# UNITED STATES PATENT AND TRADEMARK OFFICE

APPLICATION NO.	FILING DATE	FIRST NAMED INVENTOR	ATTORNEY DOCKET NO.	CONFIRMATION NO.
09/172,553	10/14/1998	JAMES E. GREEN	2914.IUS	9441

# Office Action Summary

## DETAILED ACTION

**Fig. 22**

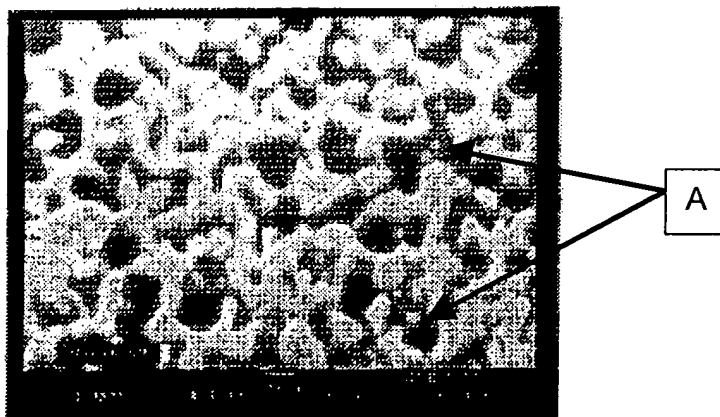
Regarding claims 31-34, the term "contiguous" is confusing. Applicant states in page 6 of the Remarks that "the term "contiguous" refers to structures (1) that touch one another, (2) that share a boundary, or (3) that are connected without a break therebetween." However, such definitions of the term "contiguous", as proposed by Applicant, is improper since at least the proposed definitions 1 and 3 are not supported by the Specification. For instance, Applicant shows in Figure 22 (see below) webs or mesas (A) that are not "contiguous" since they are separated from the other mesas or webs.

**Fig. 21**

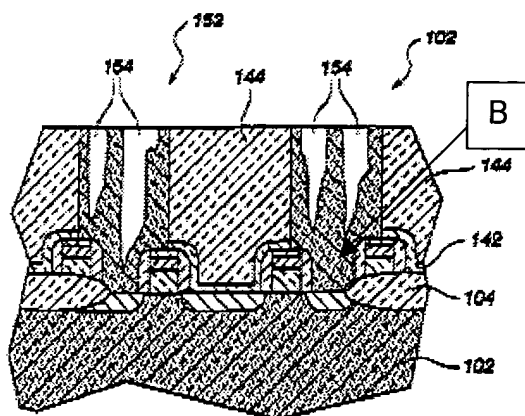
Moreover, Applicant is advised that only the proposed definition 2 apply to describe Applicant's invention since as shown in Figure 21 (see below), the webs or mesas formed between the openings (154) share a boundary (B). Thus, the Examiner would interpret the term "contiguous" as structures that share a boundary.
